42 HONEYSUCKLE DRIVE COTTAGE CREEK PRECINCT NEWCASTLE

NEWCASTLE CITY COUNCIL
DEVELOPMENT APPLICATION

ARCHITECTURAL DESIGN RESPONSES

MAY 2018
REV B

3.7 RESIDENTIAL AMENITY:

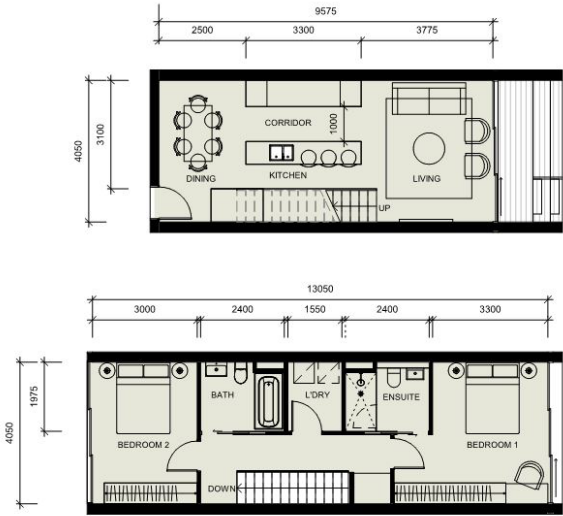
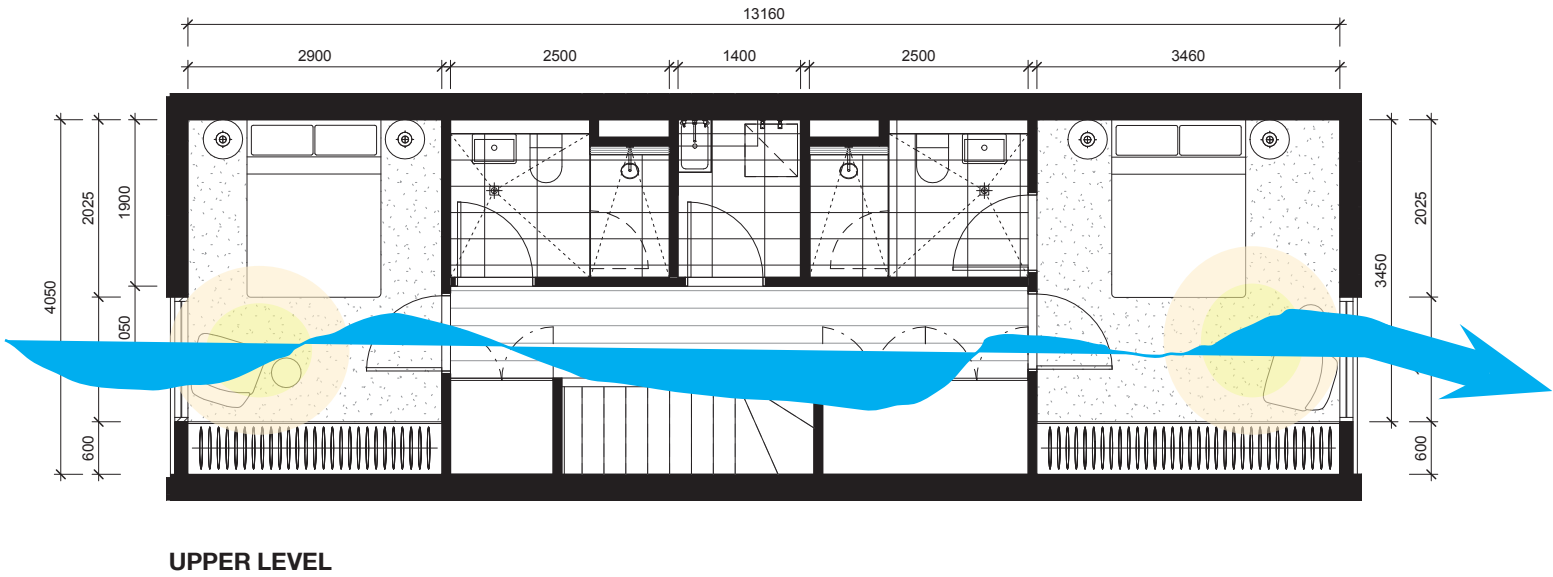
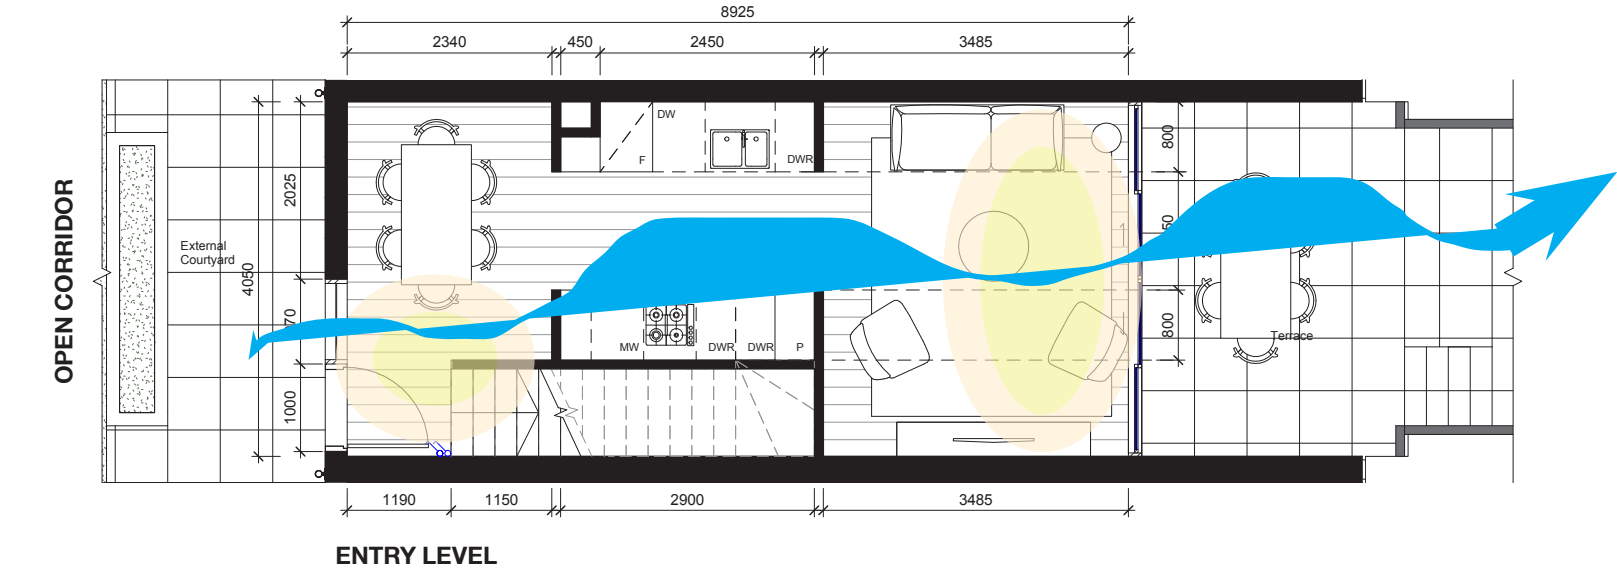
Habitable room depths for apartment type 2C which exceeds the ADG

Recommendation, including an assessment of environmental performance of the apartment given its dimensions and consideration of options available to maximise natural ventilation and daylight access

Minor amendments to internal layout of Apartment type 2C should be considered to improve functionality of the ground floor living space including consideration of kitchen layout and adequacy of circulation

Habitable room depth at the entry level is 8925m. With a 2.7m high ceiling level generally the overall depth according to SEPP65 is 3x (open plan) the ceiling height which equates to 8100mm. Whilst we are 825mm bigger than the guidance we can achieve both natural daylight and ventilation by use of the open external corridors and operable windows to both sides of the plan.

The upper level will also have operable windows to the bedroom facades to provide natural daylight and ventilation.

The layout to the ground floor broadly remains the same with the exception of the wider stair, the increased circulation between the kitchen and the introduction of an operable window to the side of the front entry door.

3.8 RESIDENTIAL AMENITY:

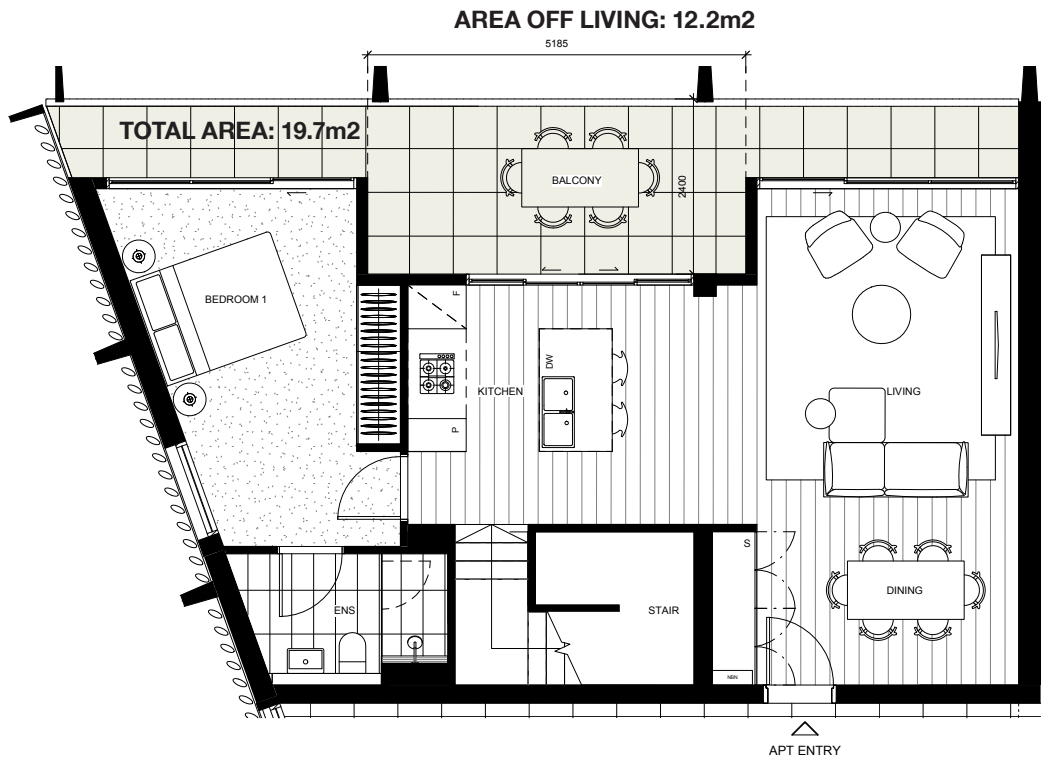
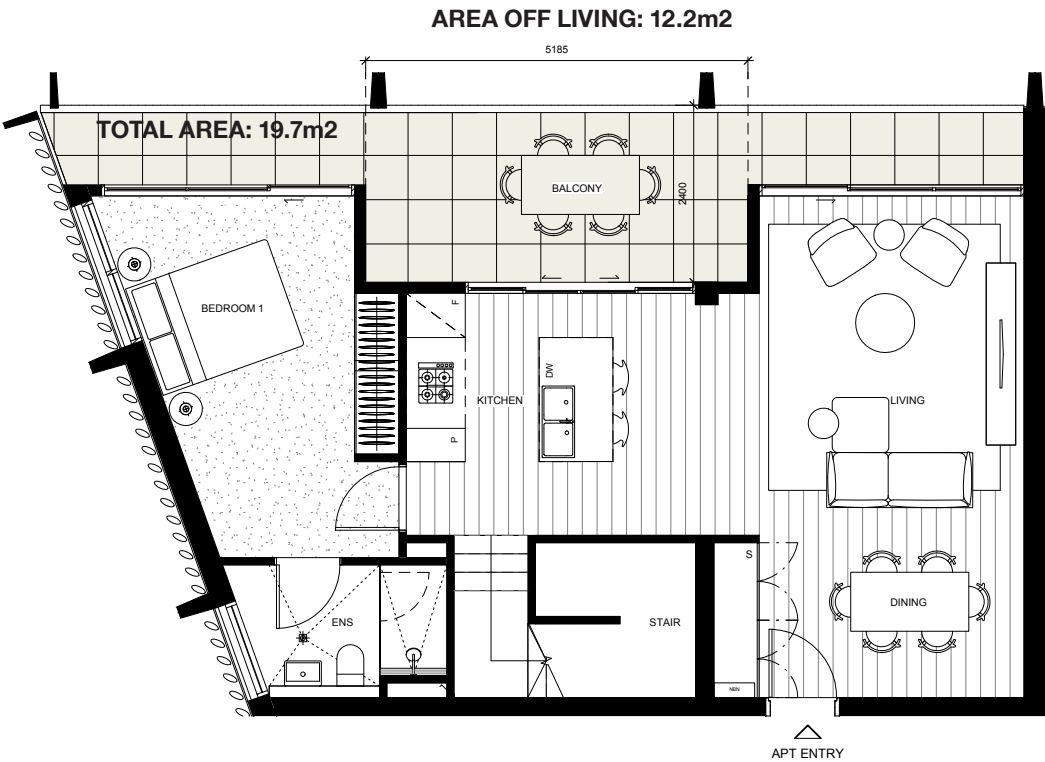
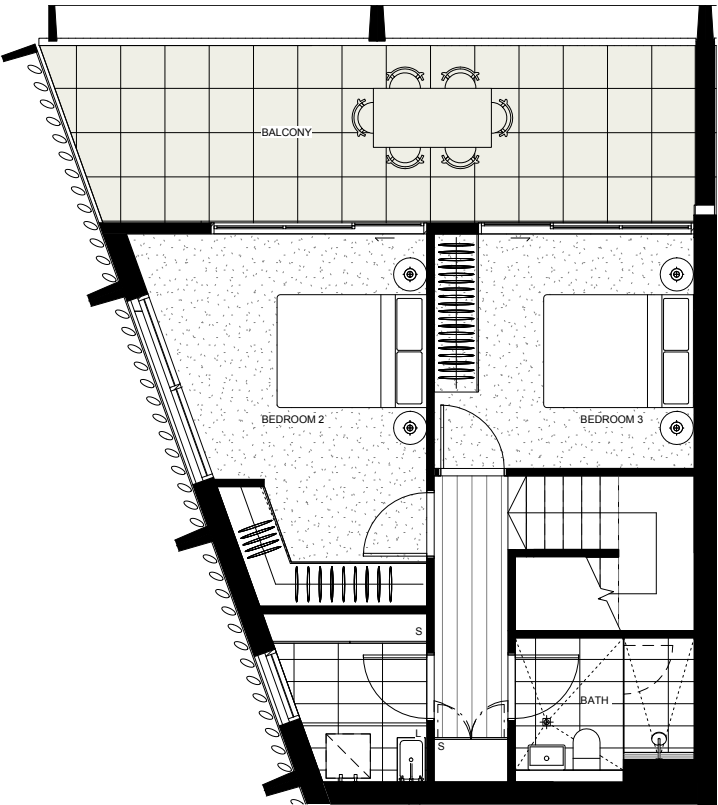
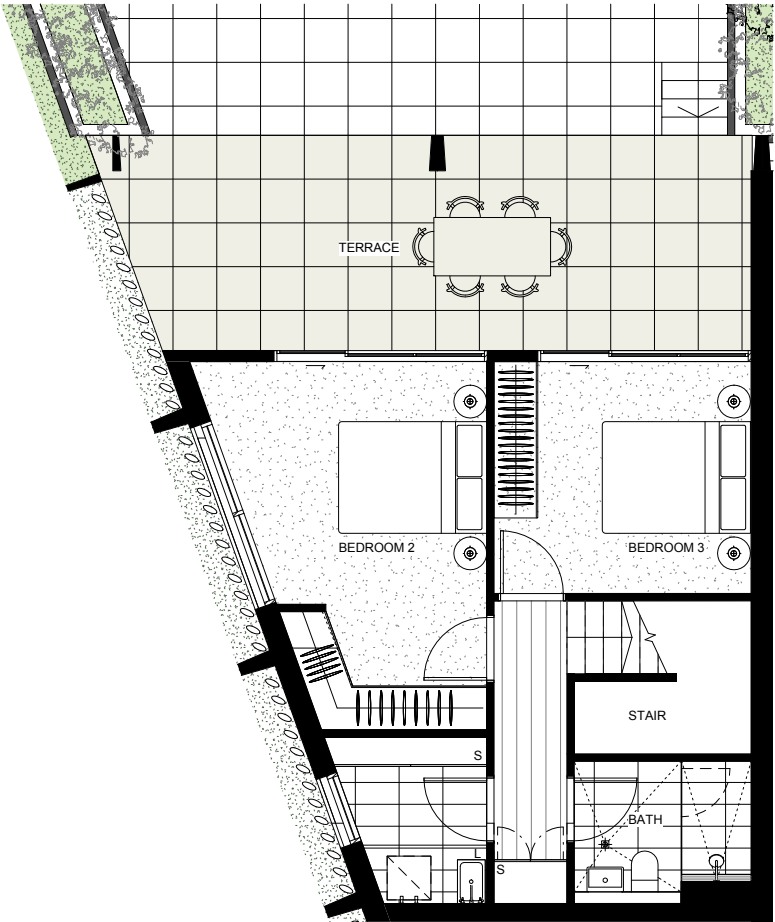
Usability of the principal private open space adjacent to living areas for apartment types 3D and 4A, including options for revised apartment layouts and/or dimensions of the open space, and indicative furniture layouts to demonstrate functionality of the private open space areas.

The depth of 2.4m has been achieved directly in front of the kitchen space providing direct access to the balcony

4.0 HOTEL COMPONENT ACCESS

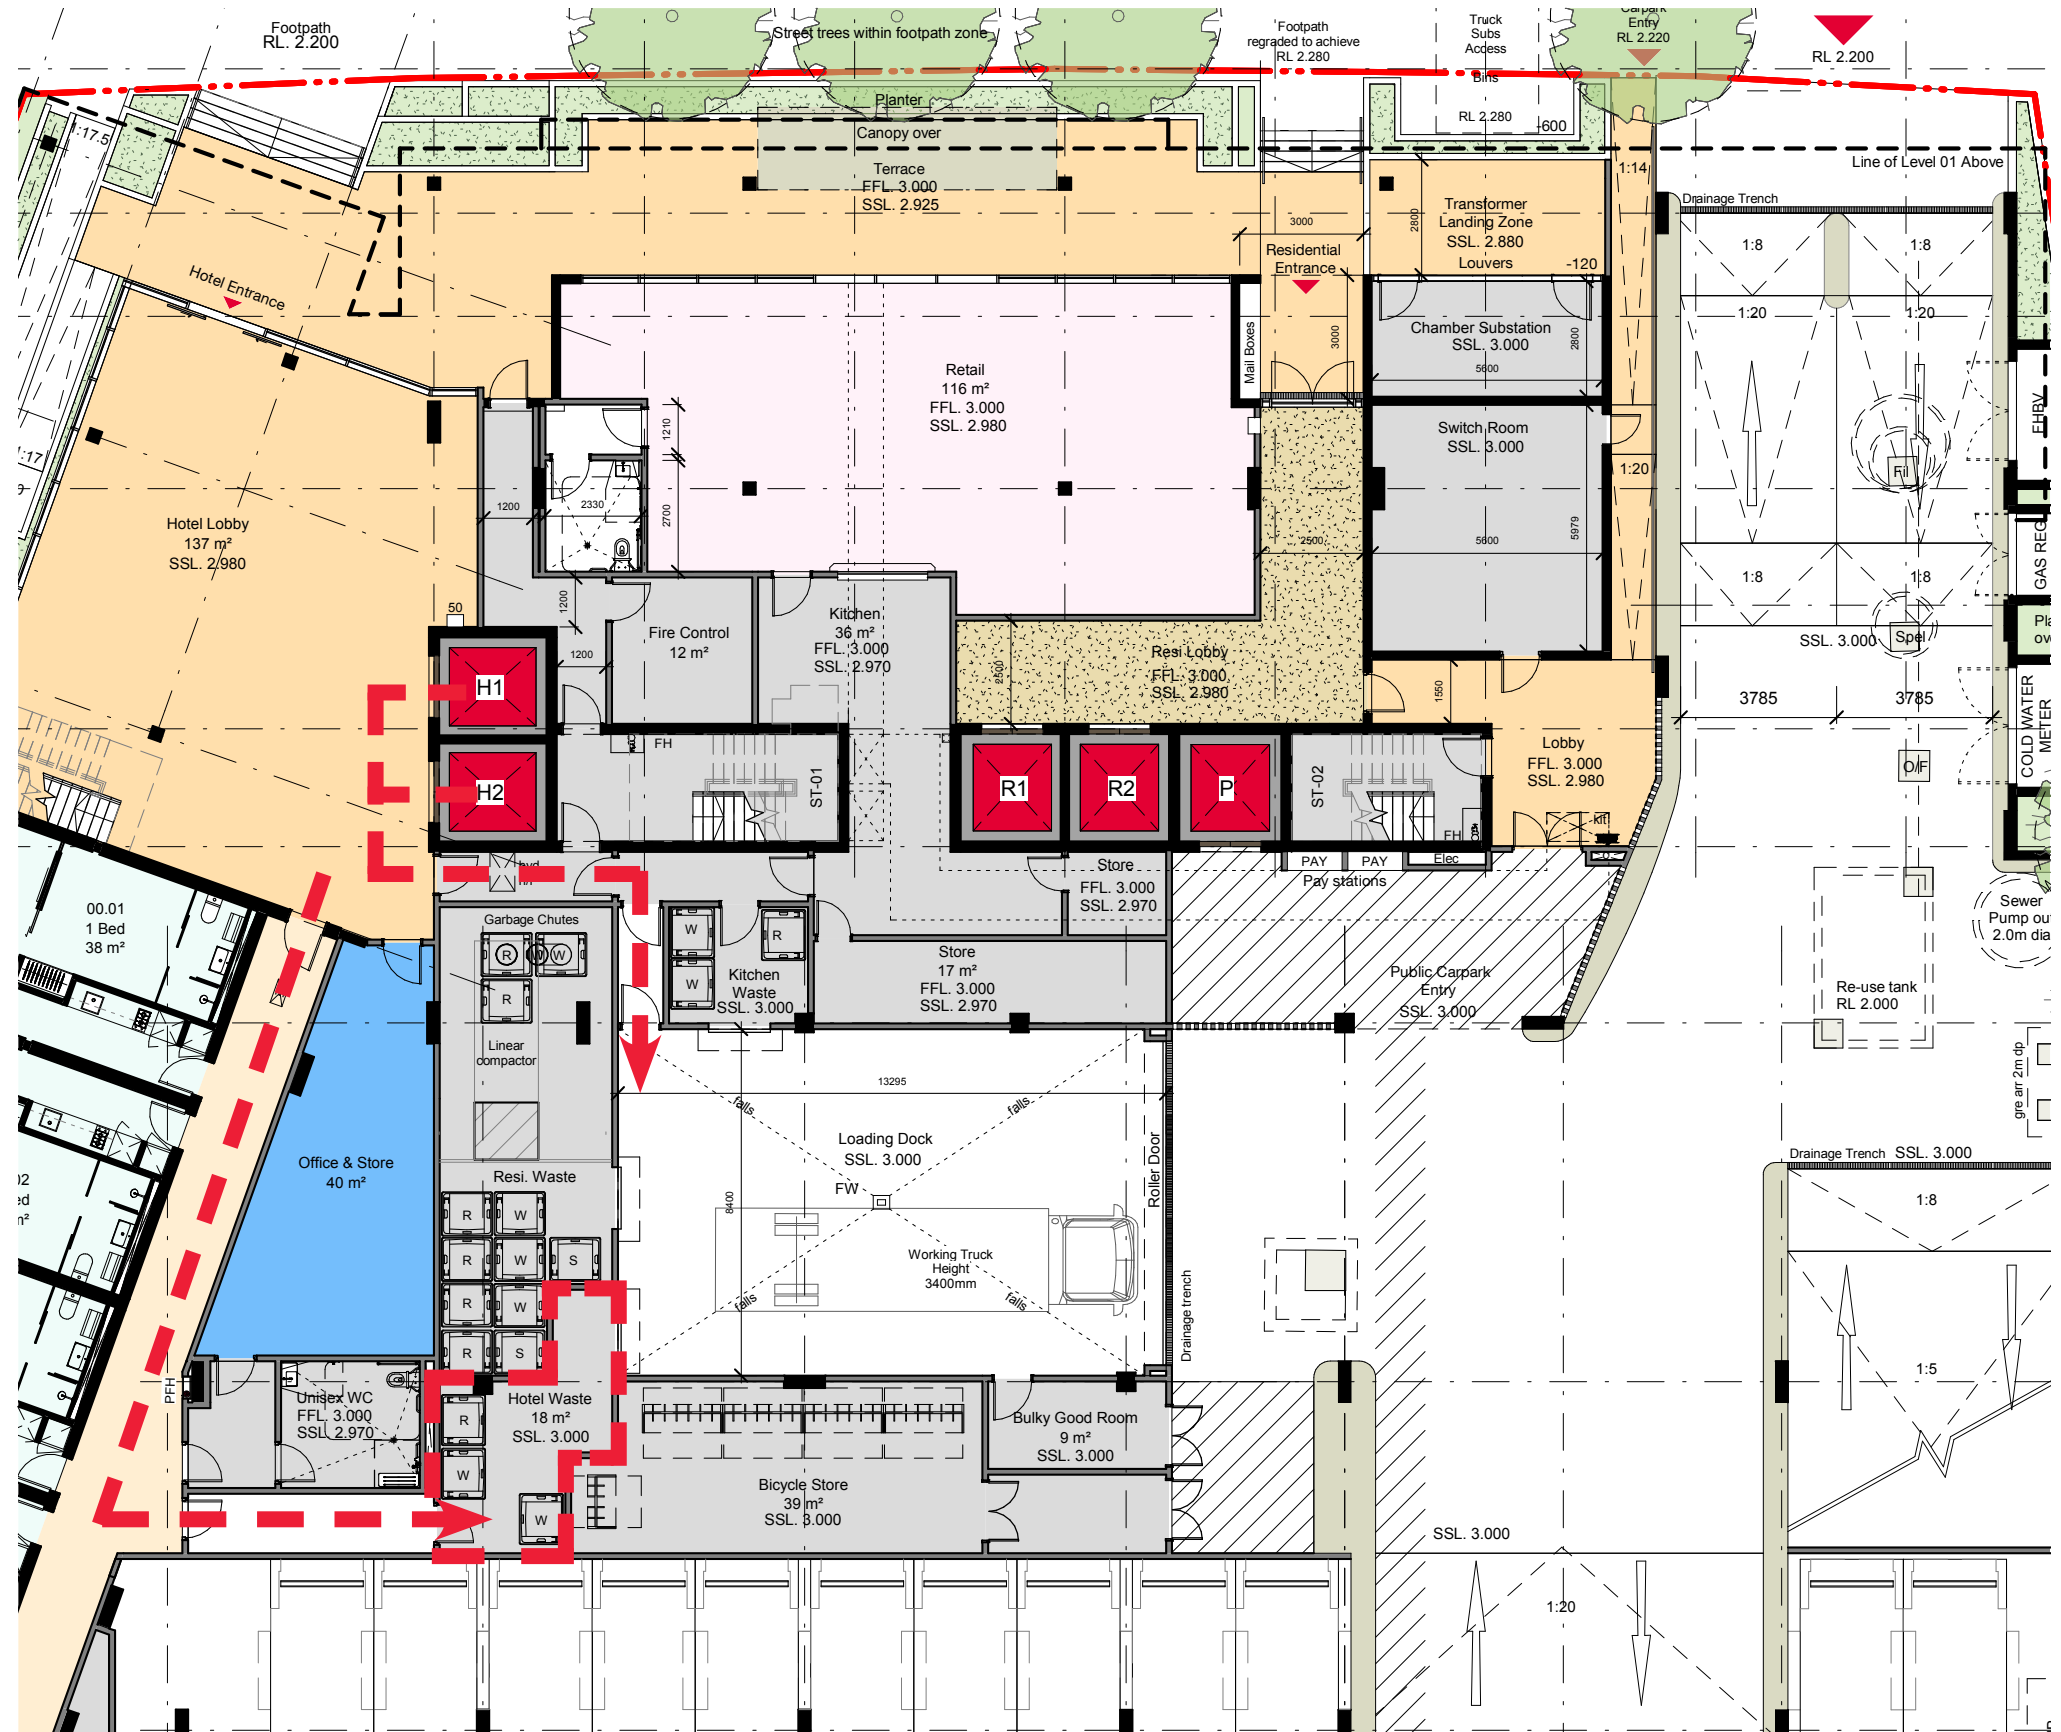
Provide further details on access arrangements for servicing of the hotel component of the development, including clear and direct access to laundry and waste facilities on the ground floor

Access for the Hotel waste facilities is via lifts H1 & H2 - this is then taken down the corridor and directly through into the hotel waste store connected to the loading dock. The waste will then be collected by a managed solution.
